AFFIDAVIT OF CHRISTOPHER BOWCOCK

Burnaby Terminal Fire Lane Compliance Memo

TMEP Burnaby Terminal Fire Lane

Subject: TMEP, Fire Truck Access submissions

Attachment: Figure-01 to 05

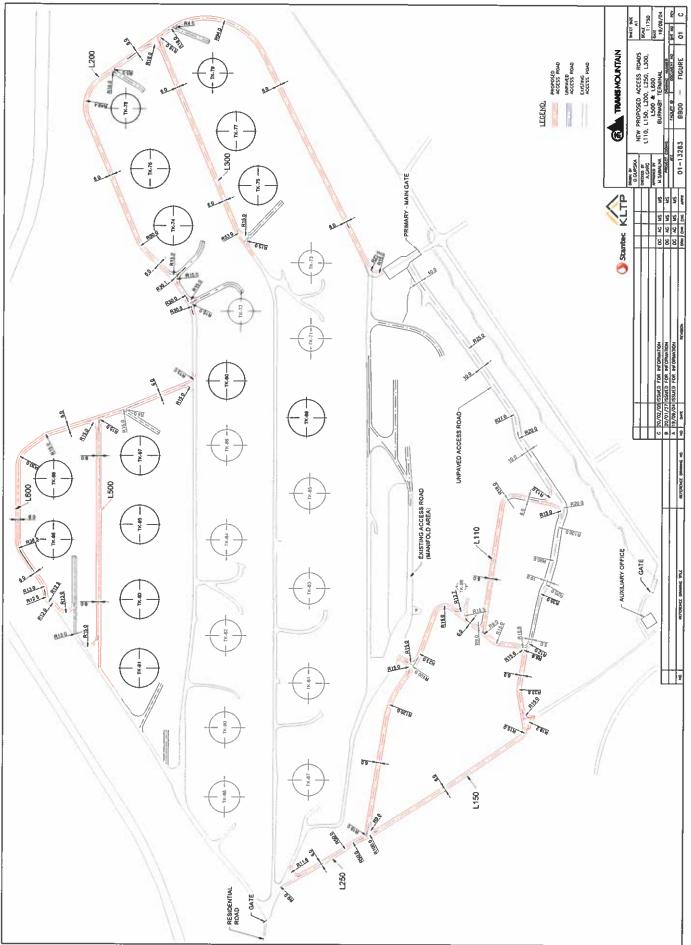
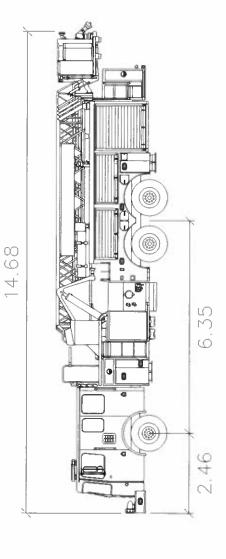
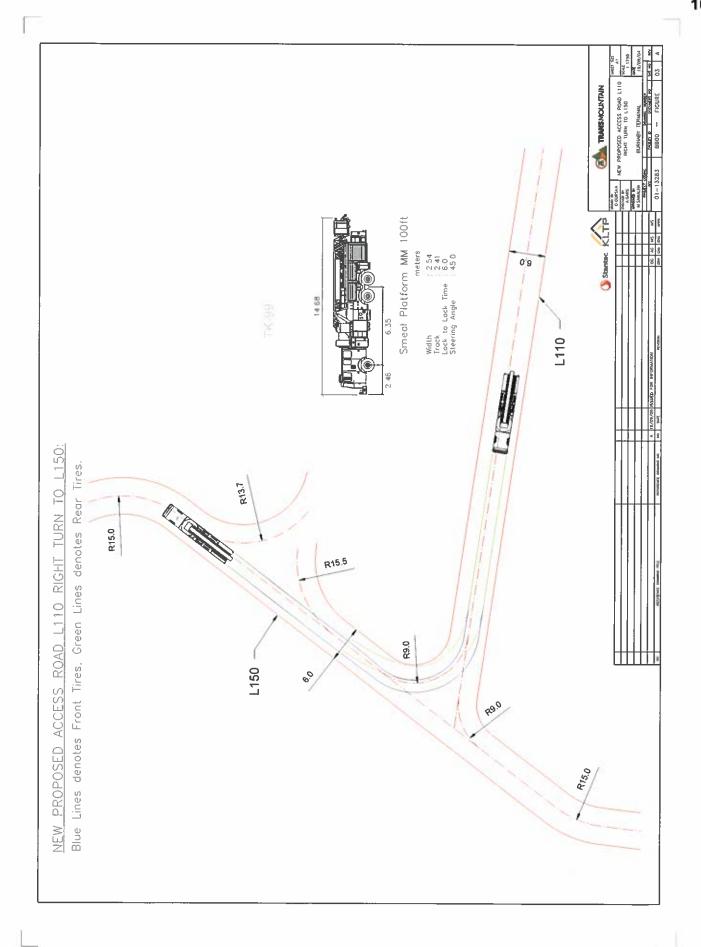
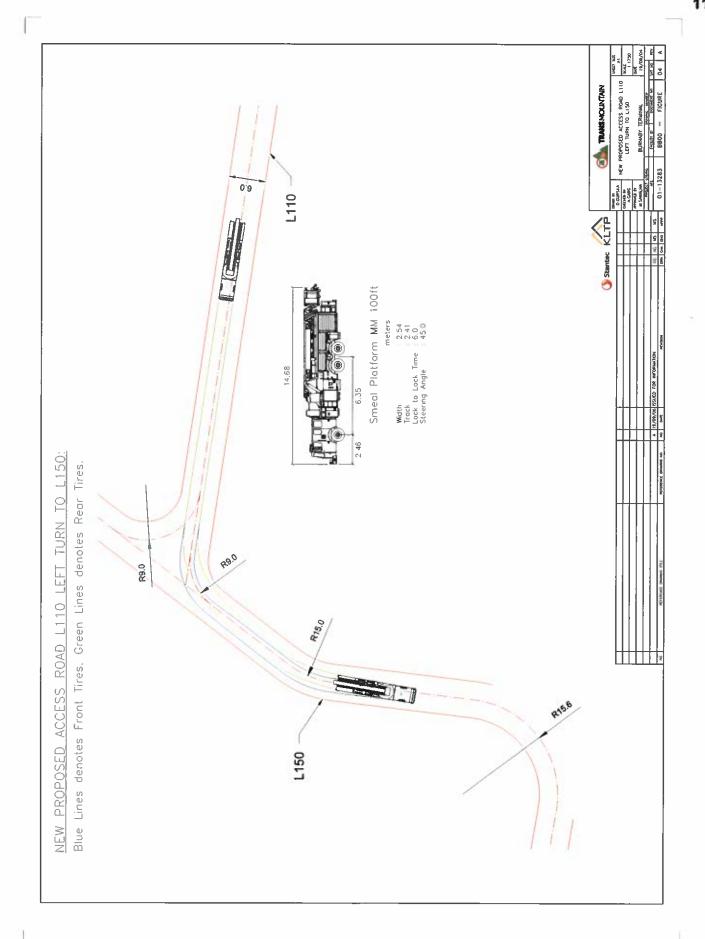
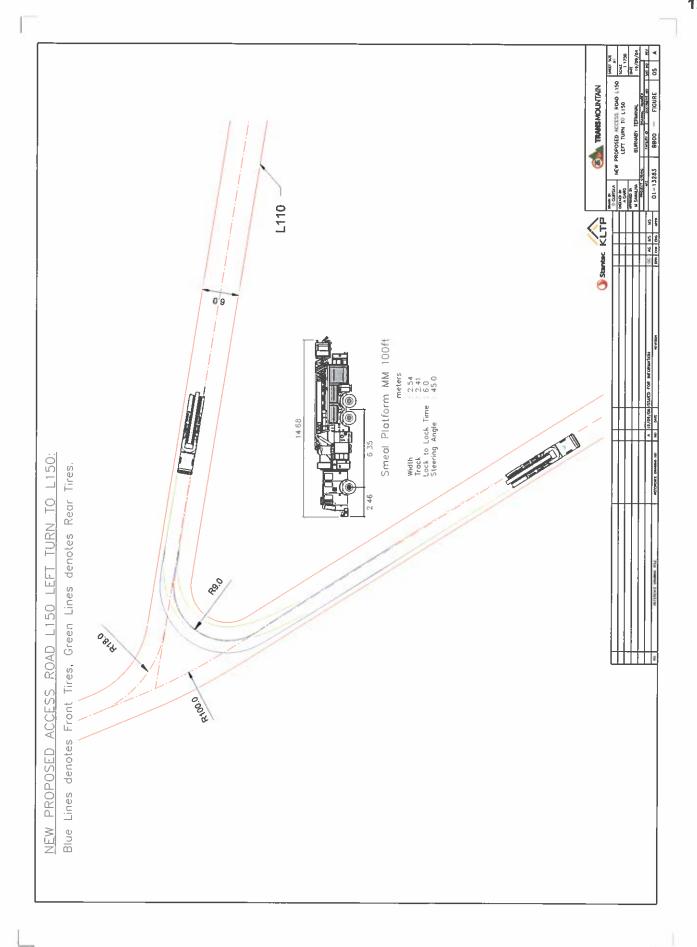
On reviewing the current design, the New Proposed Access Roads are in compliance with the requirements of BCBC 2018, Section 3.2.5.6. except for the turning radiuses of the access road L110 to the access road L150 (9m radius). Stantec has performed an AutoTURN simulation for a Firetruck in the two areas that have 9m radius, the AutoTURN Firetruck simulations show that the assumed Firetruck should be able to make the two corners, more details on the findings are presented in the attached Figurers (Figure 01 to 05).

- The unpaved access road which is on the South Side of the ISWRA (this access road is unpaved, and the width of this road is less than 6m, therefore can't be used as a Fire Lane).
- The unpaved access road running from the SE corner of the ISWRA to the main gate (this access road is unpaved, therefore can't be used as a Fire Lane).
- The existing road which runs along the South of the Existing Manifold area.
- The existing access Points to the Terminal such as (Primary Main Gate, Auxiliary Office, Auxiliary Residential Road on West Side).
